SUBJECT: ISSUANCE OF AMENDMENT ON TRITIUM PRODUCING BURNABLE ABSORBER ROD
LEAD TEST ASSEMBLIES (TAC NO. M98615)

Amendment No. 8
License No. NPF-90

SAFETY EVALUATION BY THE OFFICE OF NUCLEAR REACTOR REGULATION
RELATED TO AMENDMENT NO. 8 TO FACILITY OPERATING LICENSE NO. NPF-90
TENNESSEE VALLEY AUTHORITY
WATTS BAR NUCLEAR PLANT, UNIT 1
DOCKET NO. 50-390

Figure 1. Calculated coolant temperature for fuel sub-channel and TPBAR annulus for "Condition I" assuming a 148% assembly peaking factor.

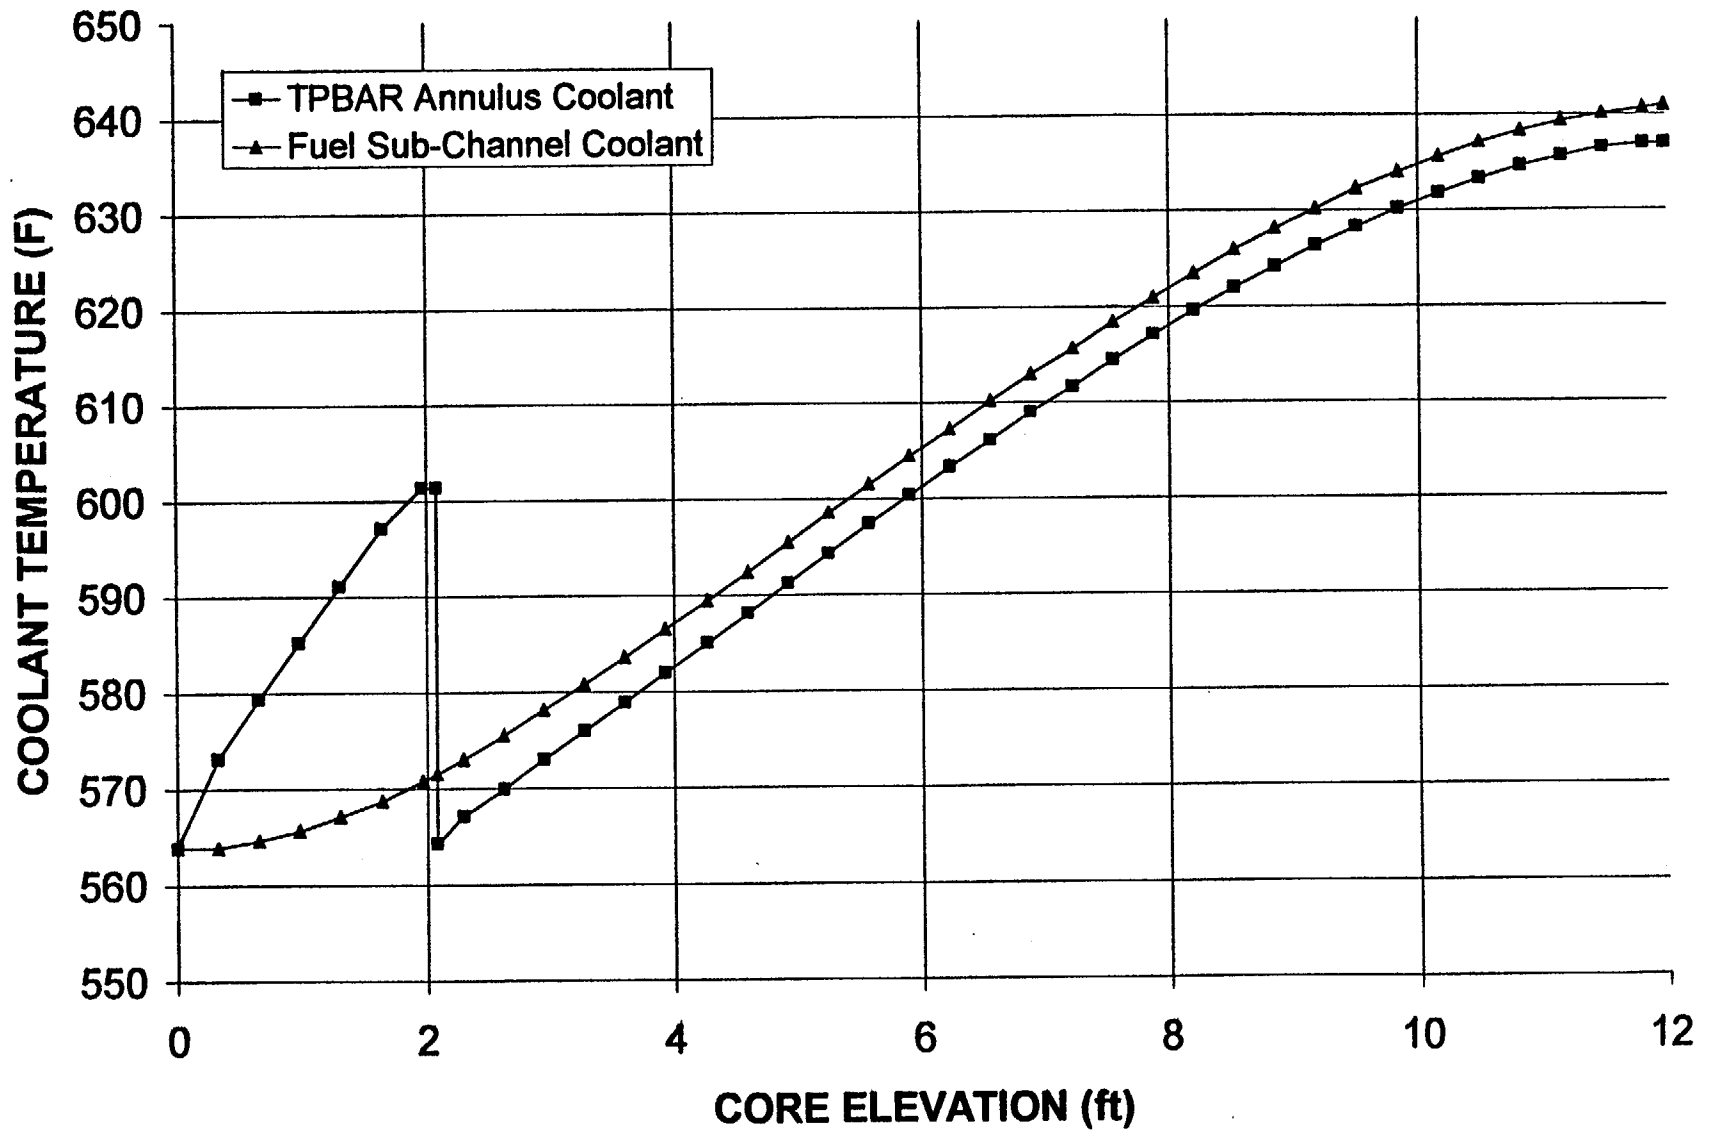
A summary of some of the audit calculation results is shown in Figures 1 through 3. Figure 1 shows the calculated TPBAR annulus and fuel sub-channel coolant temperatures for Condition I with a 148 percent assembly peaking

Figure 2. Calculations with different power shapes show relatively-low sensitivity of limiting conditions to the actual axial power shape.

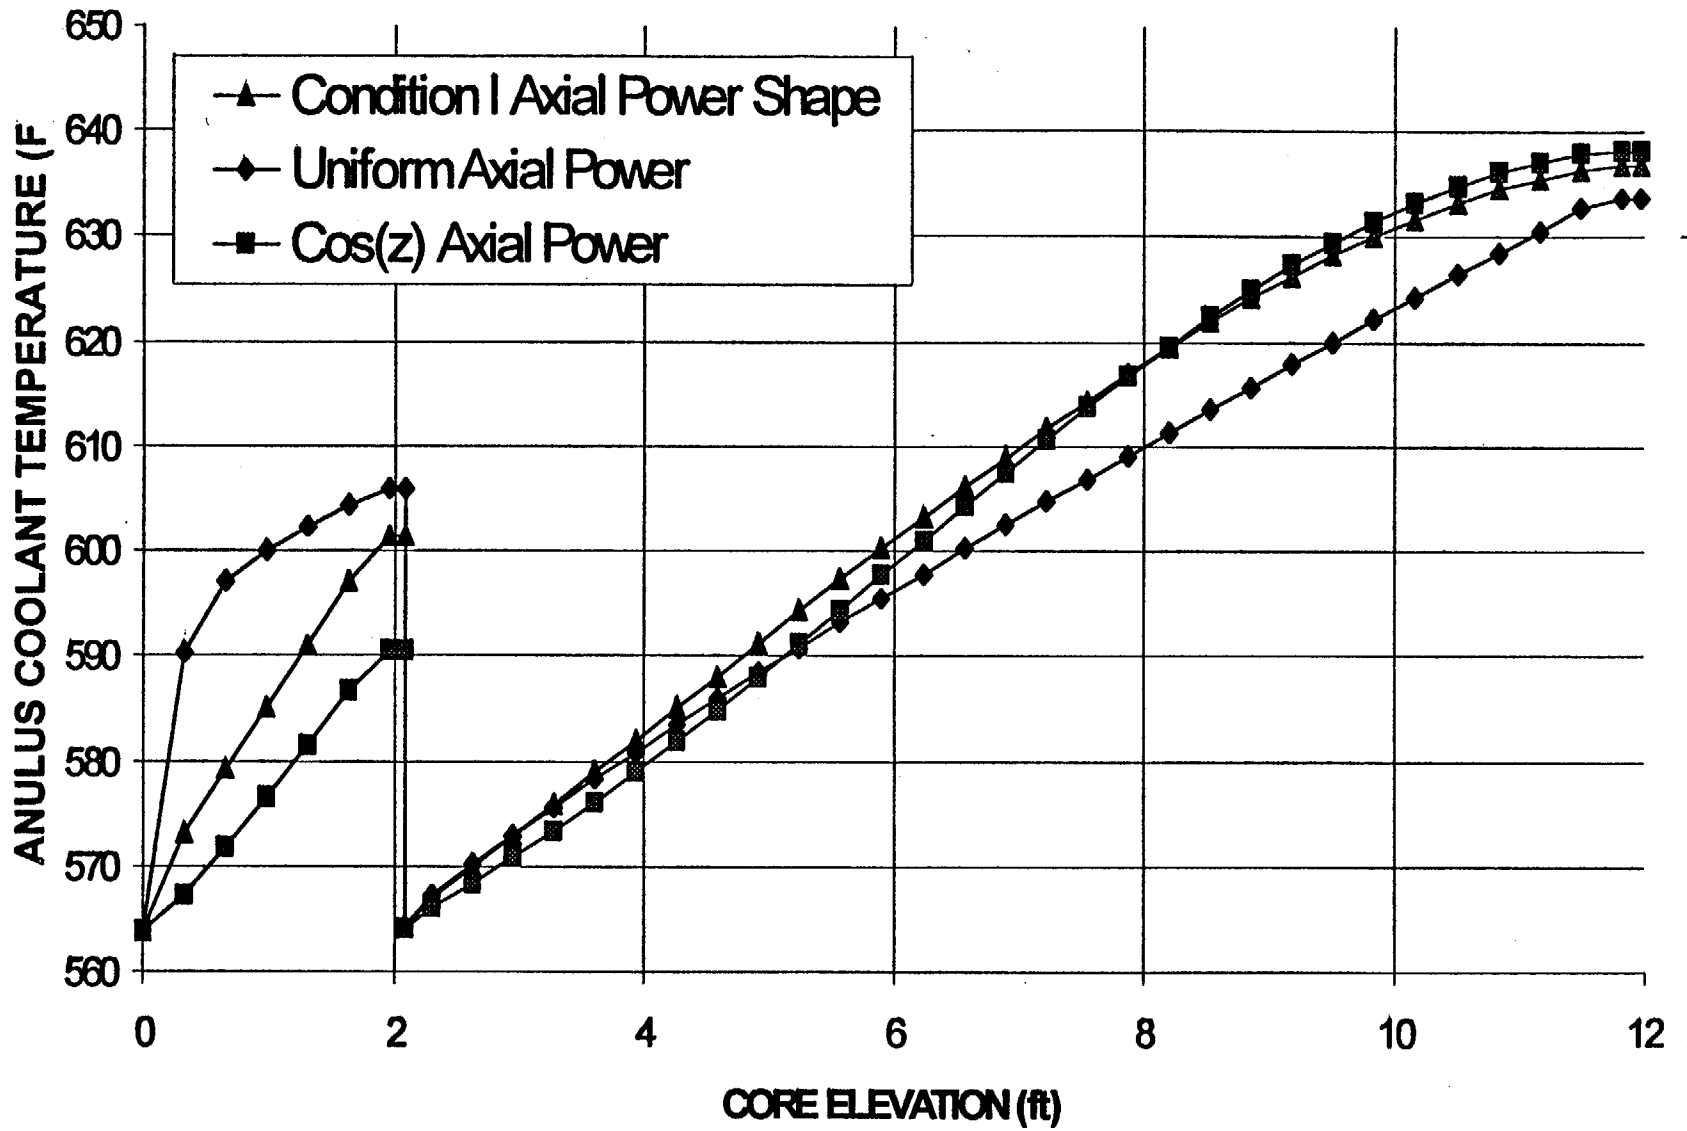
Figure 2 studies the sensitivity to different axial power distributions. The Condition I power shape is shown along with a uniform and a cosine distributions. As it can be observed, the outlet temperatures are fairly insensitive to power distribution. The temperature in the dash pot is very sensitive to the assumed power distribution in the dash pot, but this temperature is not limiting under any realistic power shape. Thus, the staff concludes that the conclusions in TTQP-1-038 can be generalized to all expected axial power shapes.

Figure 3. Thermal coupling between TPBAR and fuel sub-channel is large. TPBAR heat can be dissipated by conduction even with a 90% blockage.

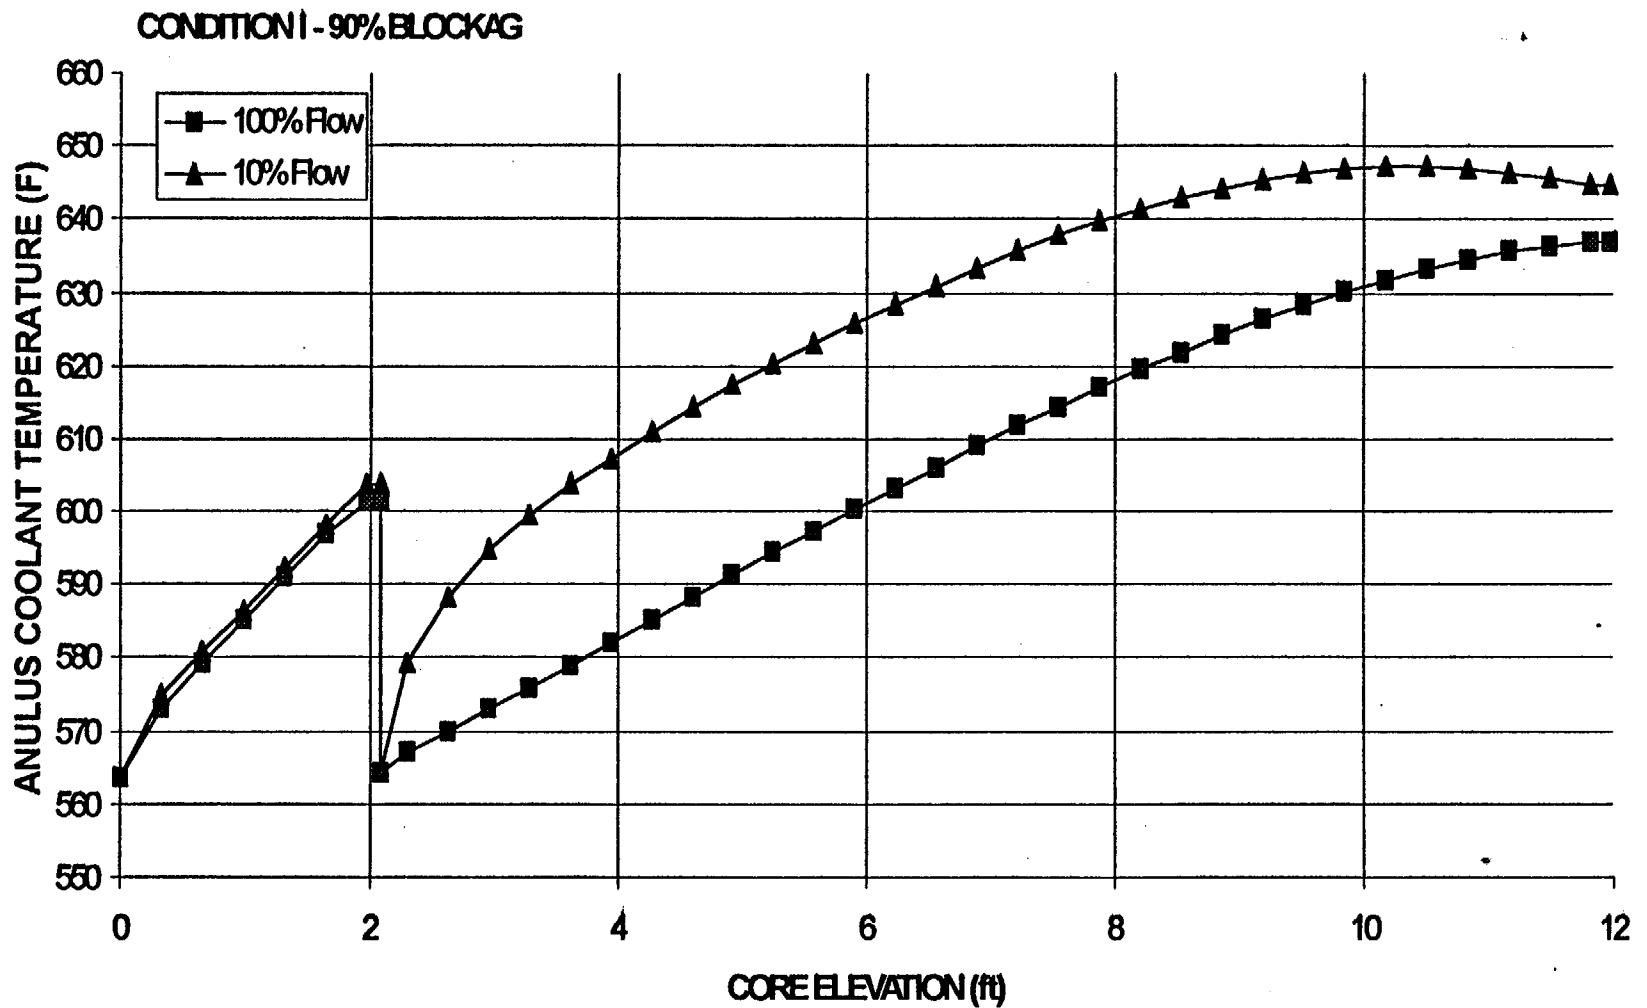
Figure 3 shows the result of a sensitivity study to flow blockage. For this calculation, ORNL assumed that only 10 percent of the nominal flow exists in both the dash pot and the upper section of the guide tube. As observed, the annulus temperature increases as heat must be conducted to the fuel sub-channel through the guide tube cladding. For this calculation, ORNL assumed the Condition I axial power shape, which has low power generation at the edges; for this reason, the delta temperature is decreased at the guide tube outlet (less heat must be conducted), and the temperature "penalty" due to a 90 percent flow reduction is only of the order of approximately 10°F. Note that the dash-pot temperature does not change significantly because most of the dash-pot heat is conducted to the fuel sub-channel through the guide-tube cladding. This is the reason why the error in estimated dash-pot flow (1.34 percent as opposed to 2.96 percent) does not affect the report conclusions.
